ADDENDUM NO. 1

The following attached changes are incorporated into requirements for the Project No. 33-SBC-1001 Contract Documents by this Addendum:

KITTITAS RECLAMATION DISTRICT

SOUTH BRANCH CANAL IMPROVEMENTS

GENERAL ALIGNMENTS EXISTING AND PROPOSED

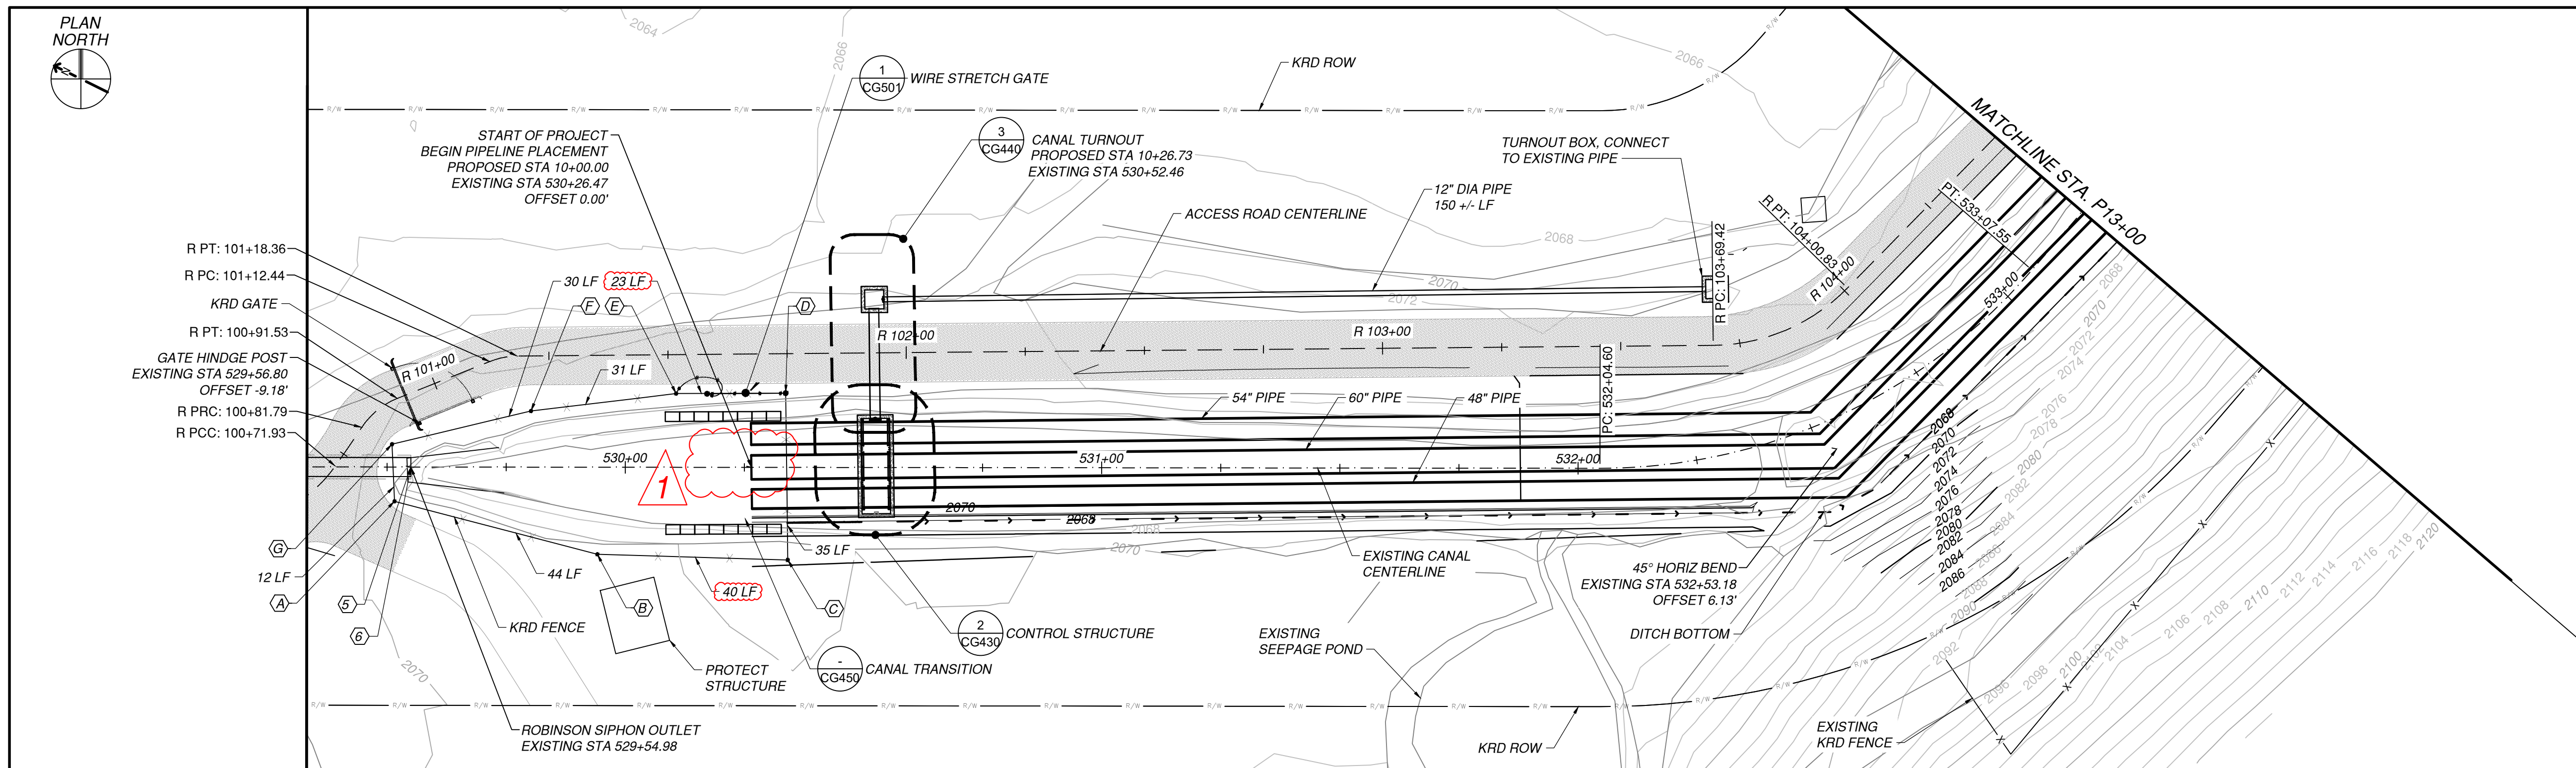
4. Drawings
 - a. Drawing G-001: Revised Drawing Index table.
 - b. Drawing G-002: Revised material hatching key.
 - c. Drawing G-006: Revised Table Headings to clarify that coordinates are in local project ground distances.

- NOTES: 1. THIS INFORMATION IS IN LOCAL PROJECT GROUND DISTANCES. SEE NOTE C-4 ON SHEET G-003 FOR INFORMATION ON CONVERTING TO HARN WASHINGTON STATE PLANE, SOUTH ZONE, US SURVEY FOOT.

CG102
 SHEET 09 OF 35

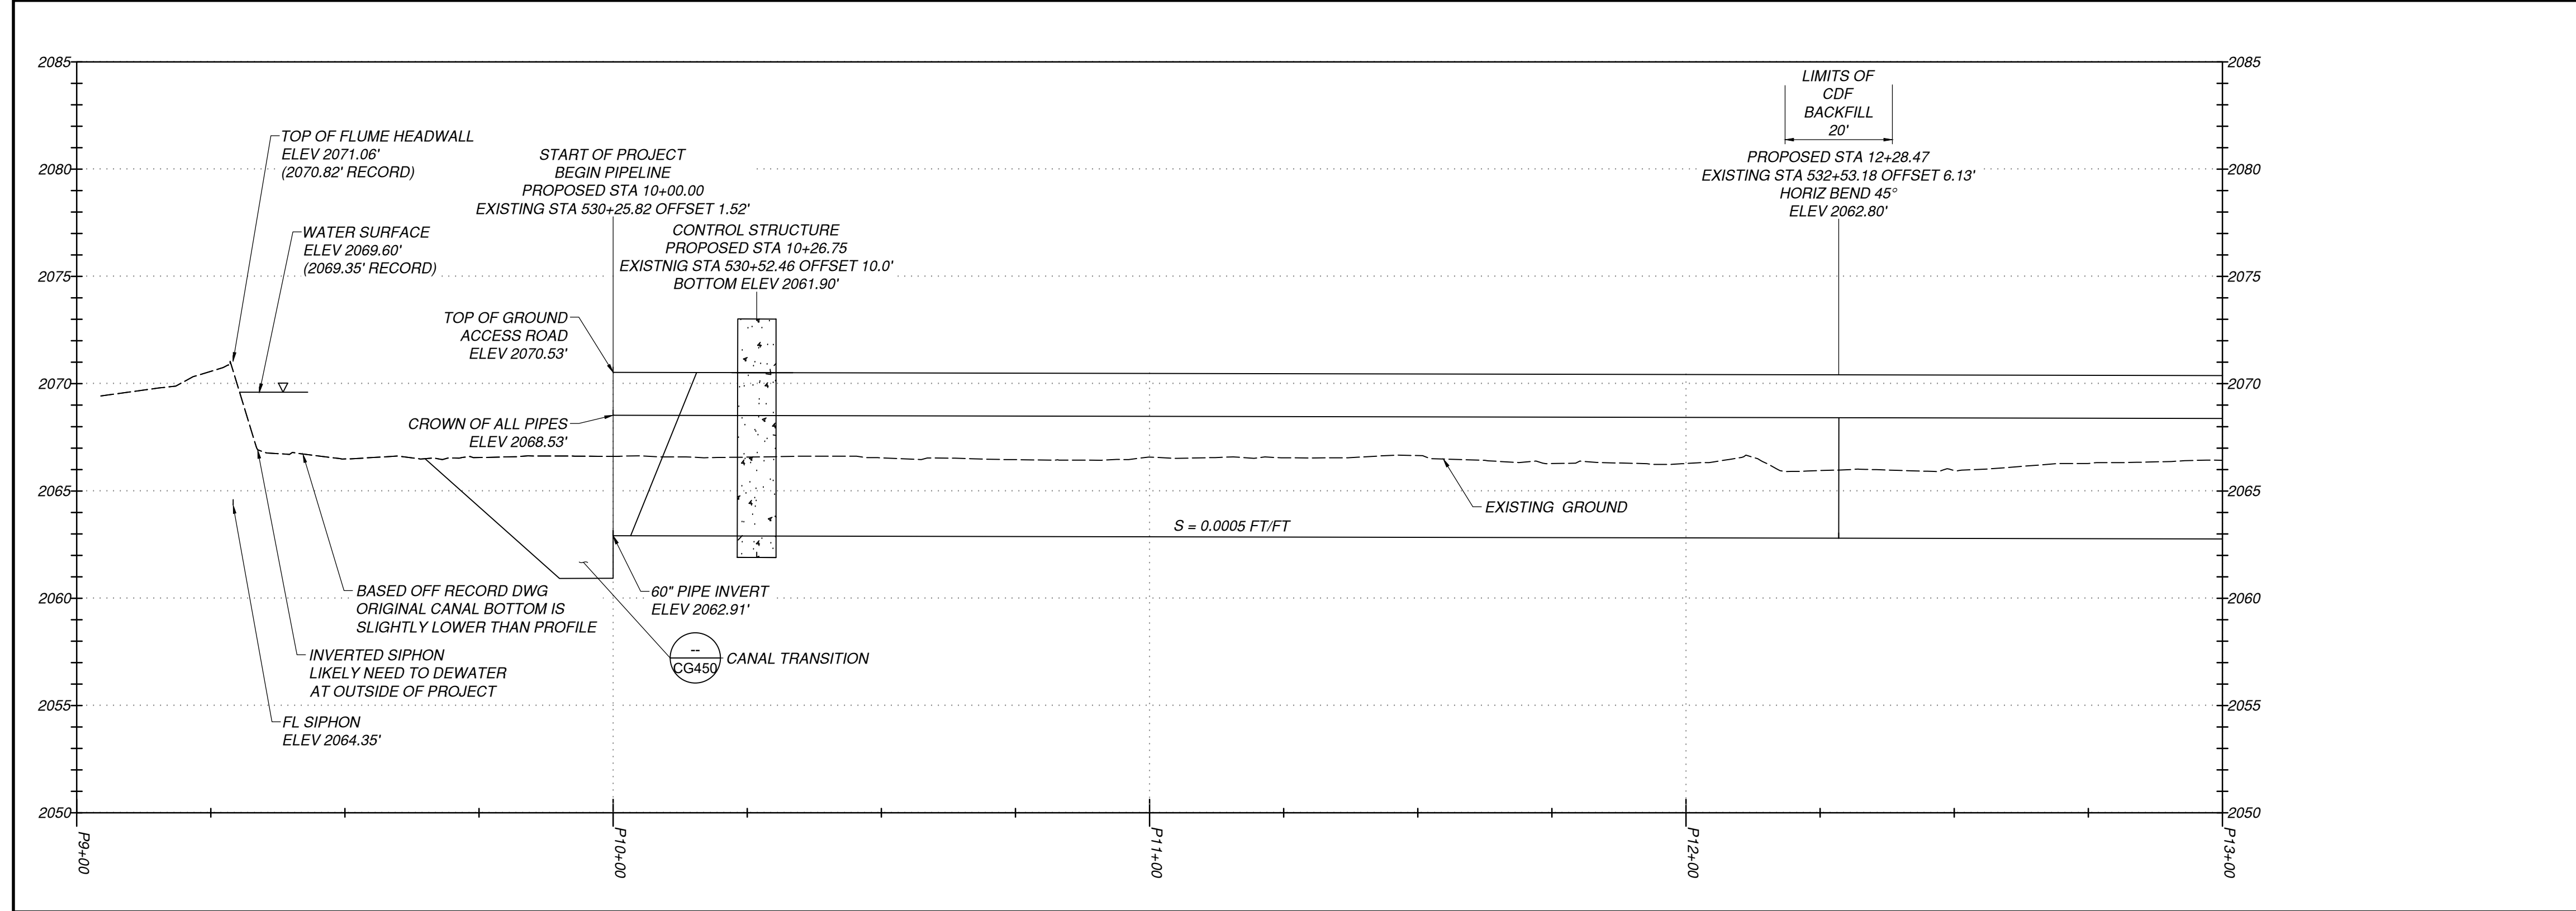
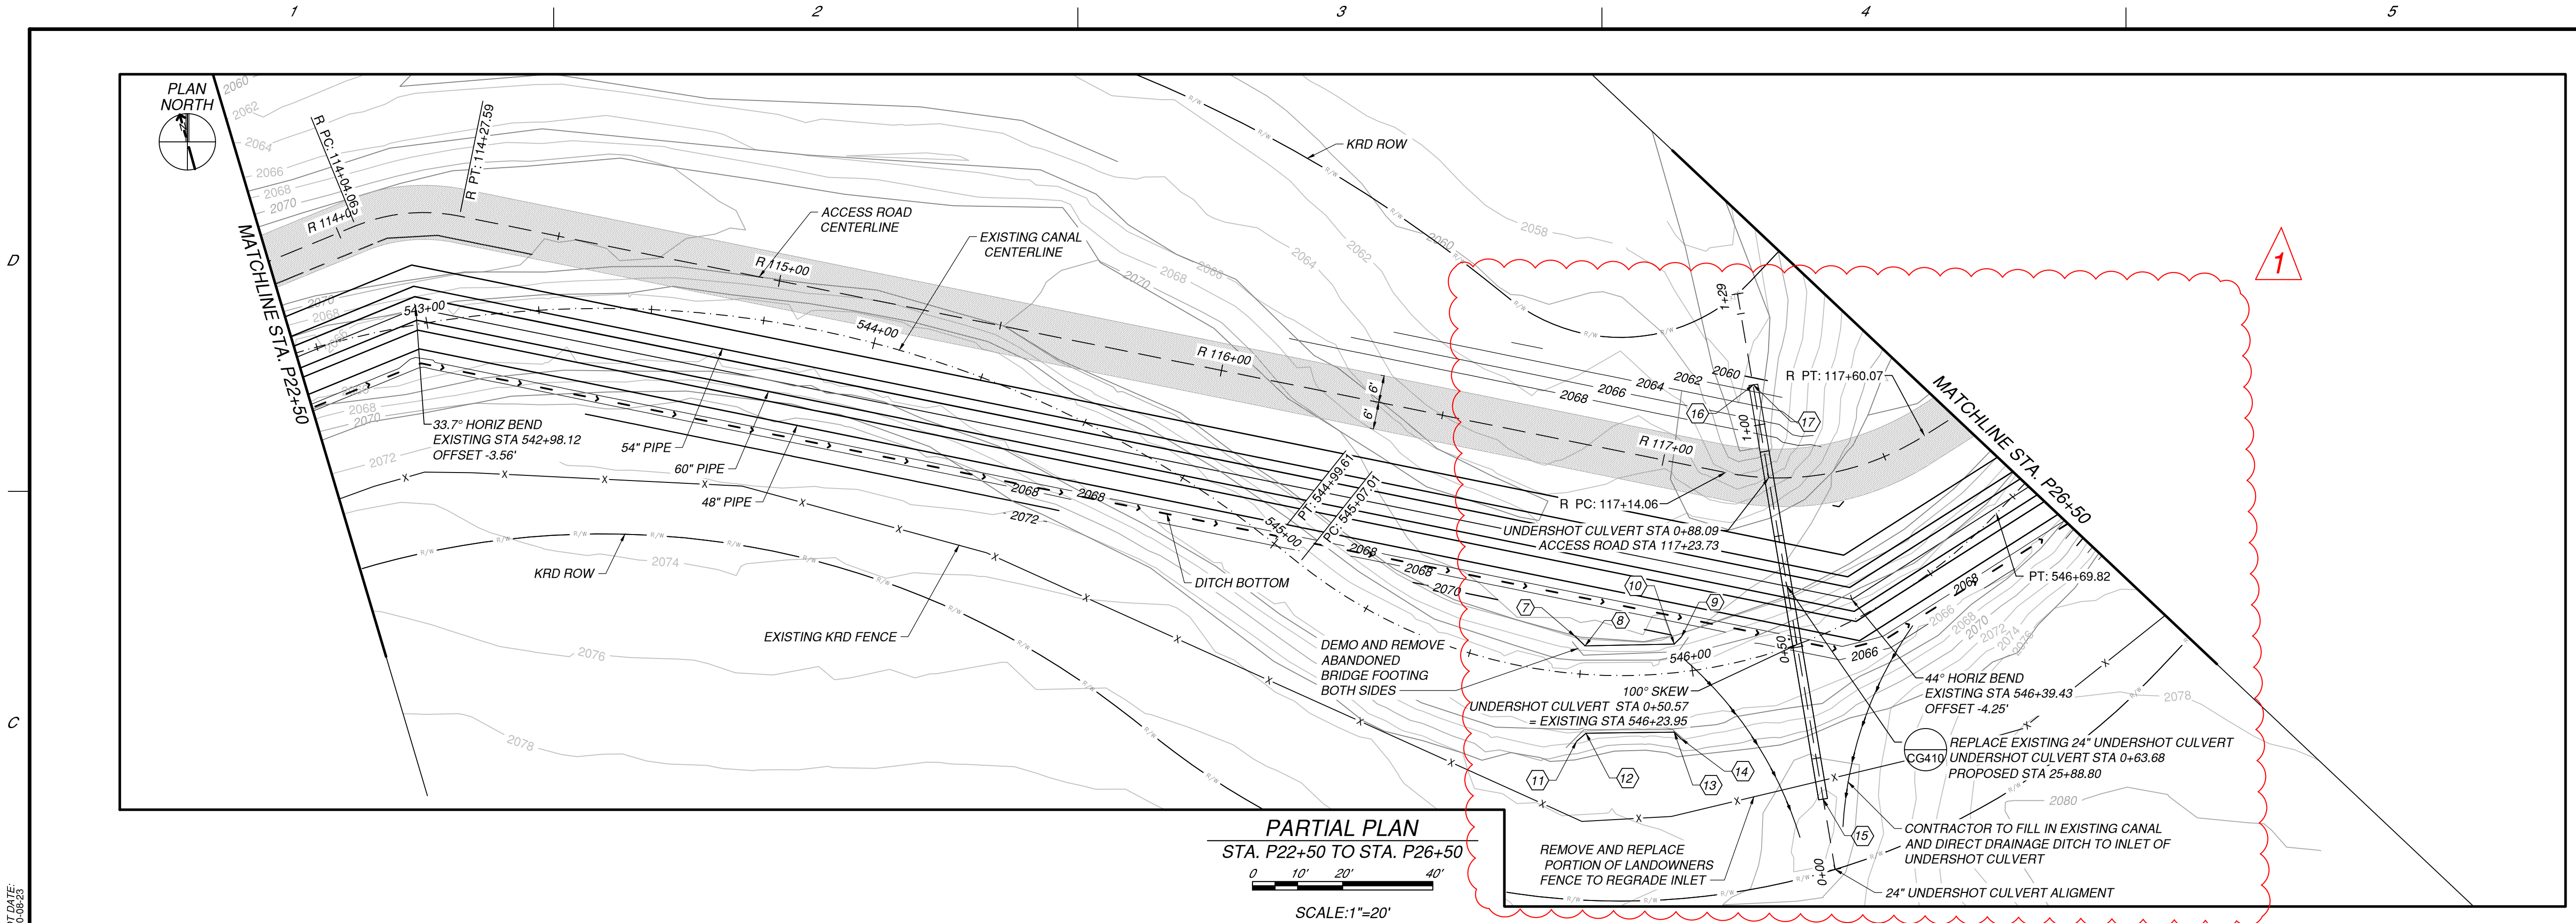
- d. Drawing CG102: Slight revision to pipeline start point to eliminate centerline offset at from existing canal centerline.
 - e. Drawing CG105: Revised inlet and outlet of undershot culvert.

REV NO	DESCRIPTION	DATE
1	REVISED TO ADJUST BEGINNING OF PROPOSED ALIGNMENT - EXTEND FENCE TO ACCOUNT FOR REPOSITIONING	08-21-2020
0	ISSUED FOR BIDDING	08-11-2020

CG301
 SHEET 14 OF 35

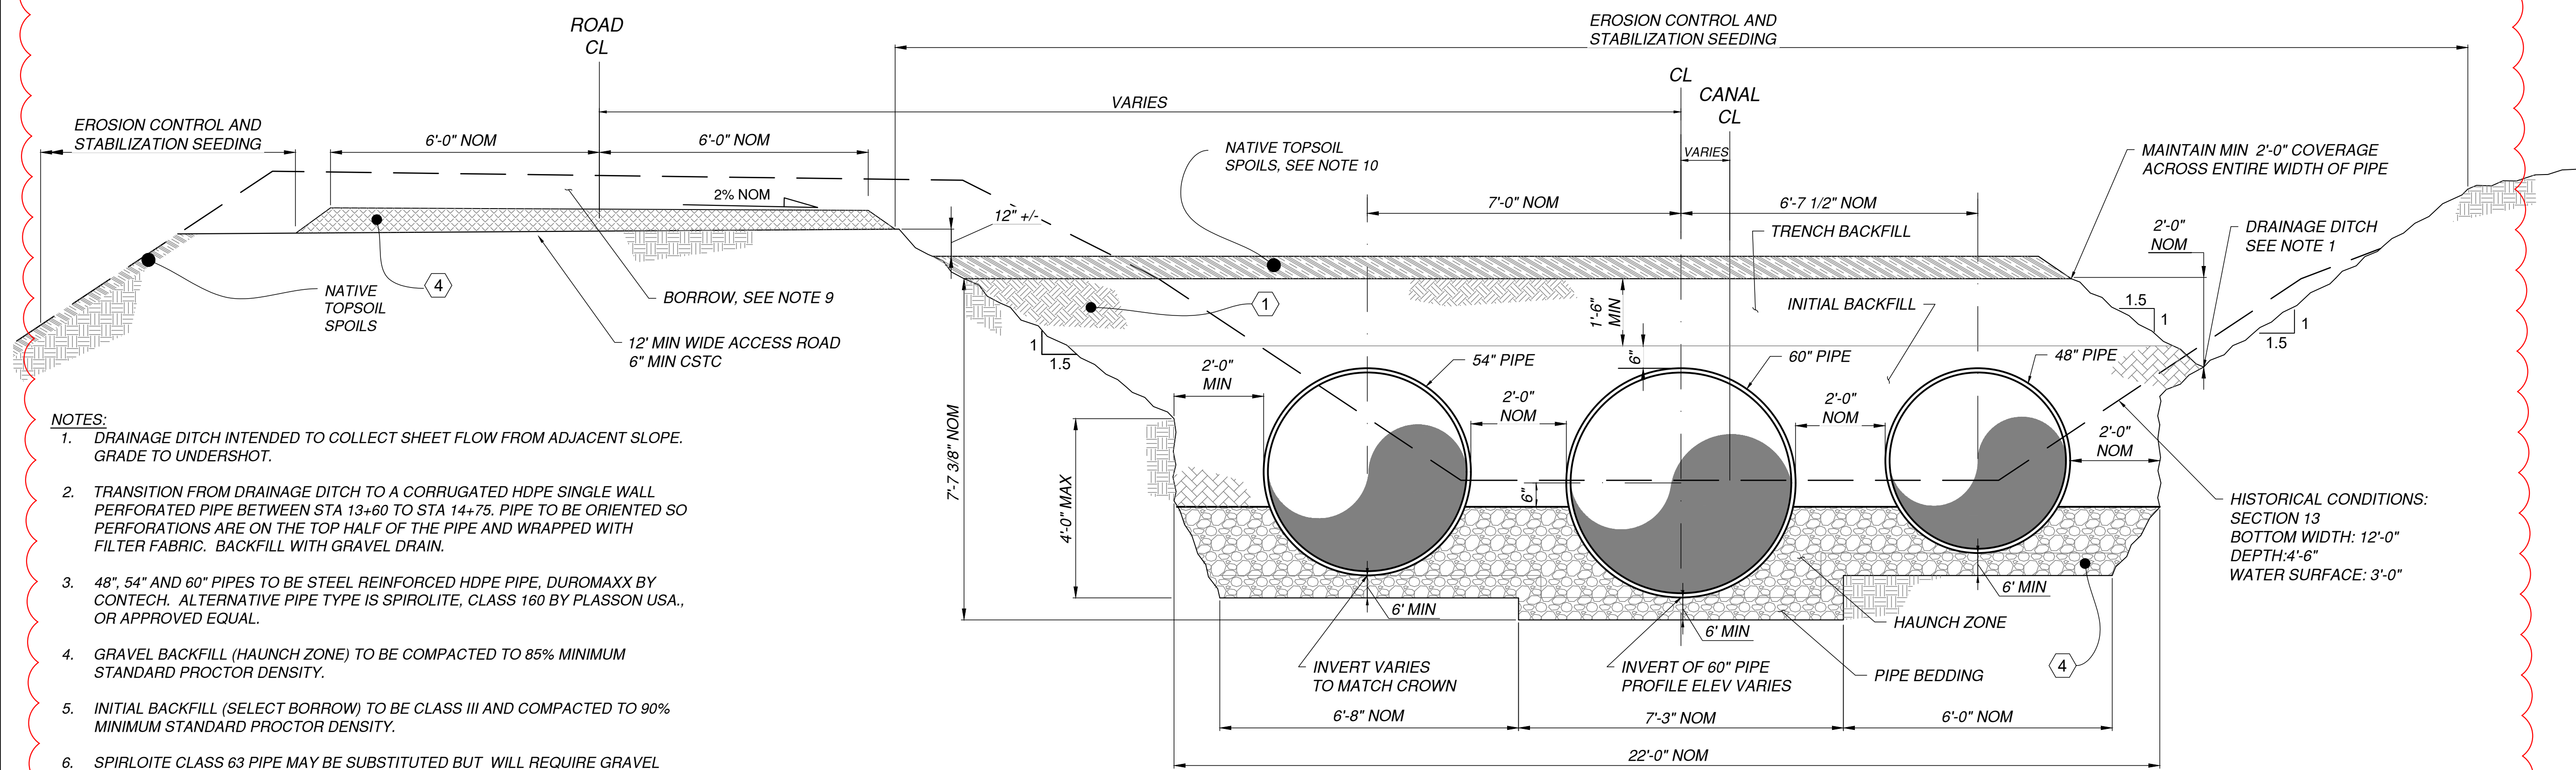
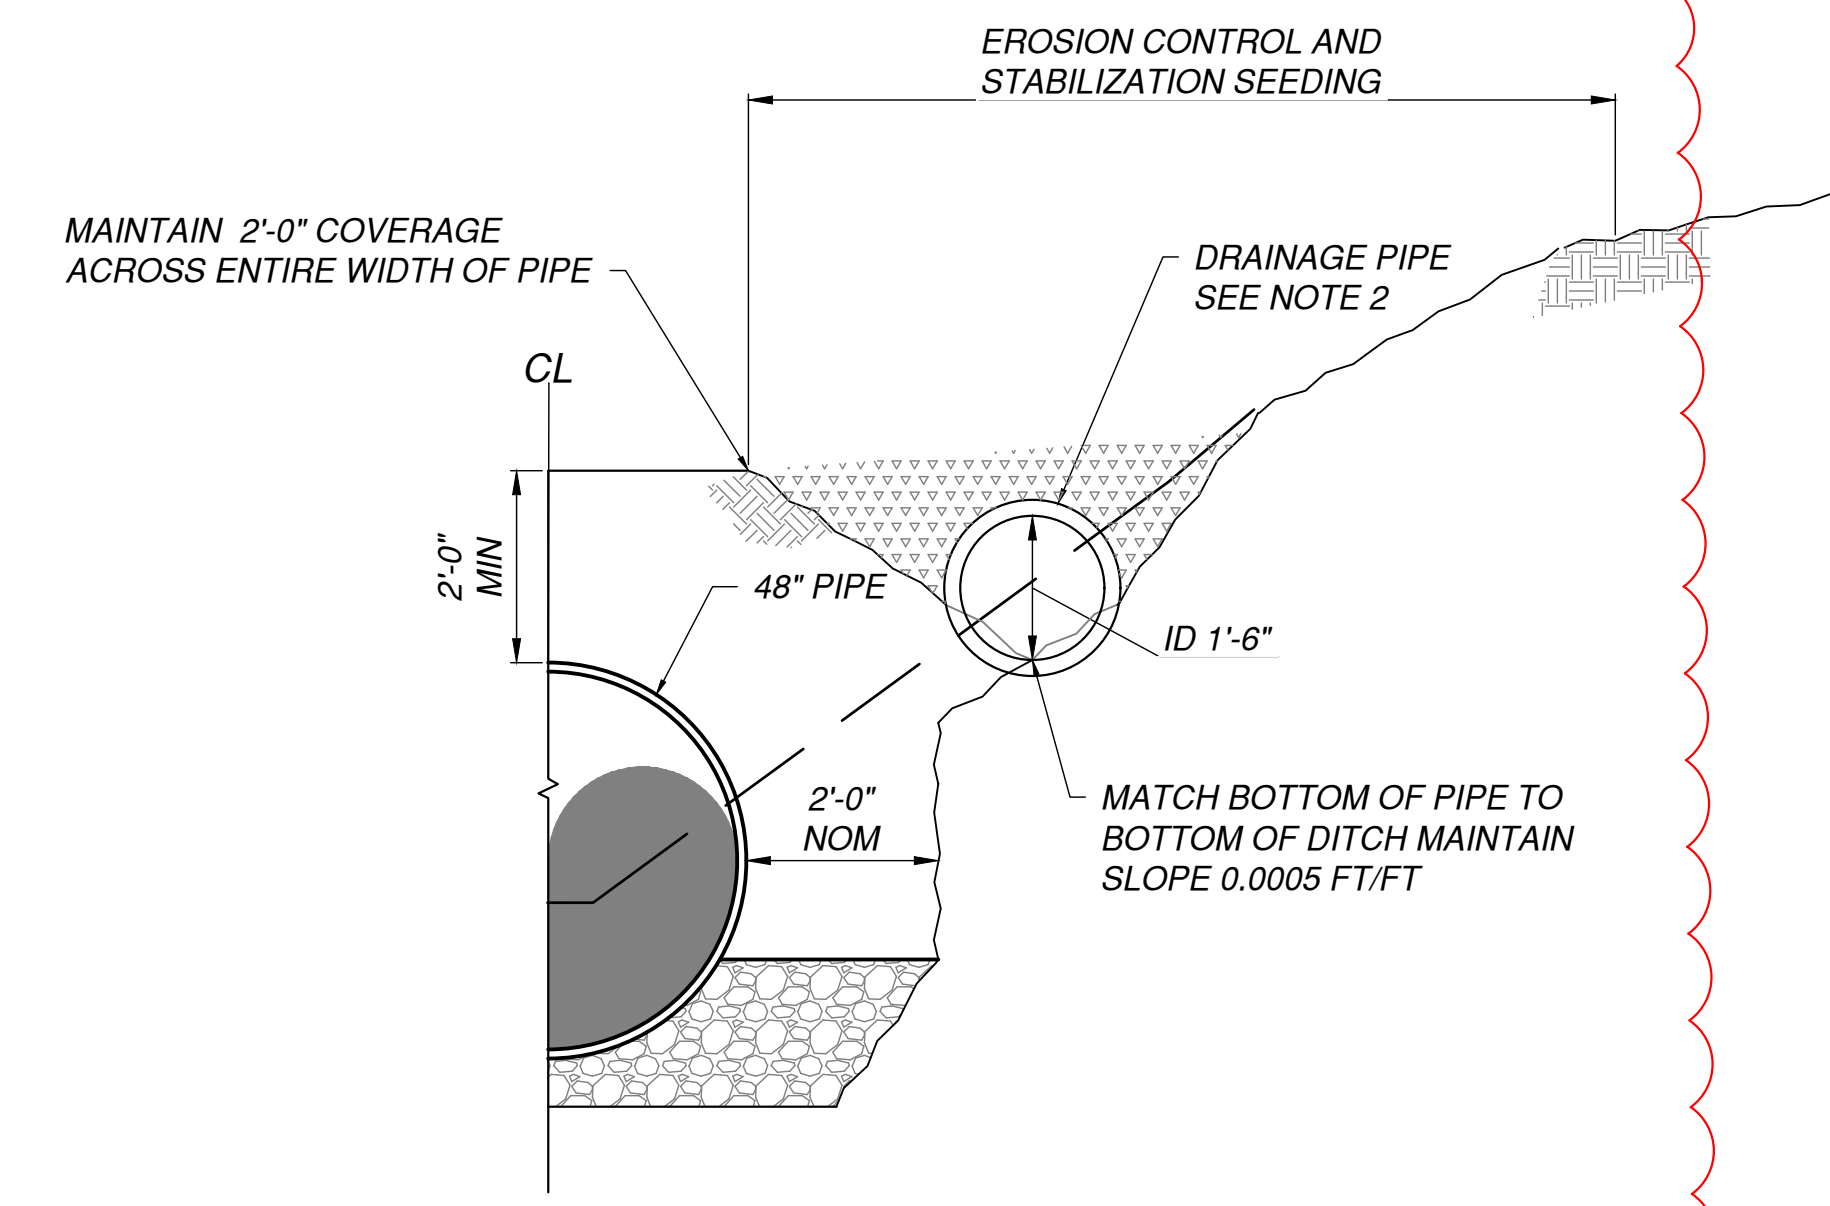
- f. Drawing CG301: Revised trench backfill material to utilize “Gravel Backfill”.
 - g. Drawing CG302: New sheet clarifying CDF backfill for thrust blocking and typical trench backfill material for alternative pipe material.

REV NO	REV BY	REV DATE	DESCRIPTION
1	JOHN ETULAIN	08-21-2020	REVISED TRENCH BACKFILL MATERIALS
0		08-11-2020	ISSUED FOR BIDDING
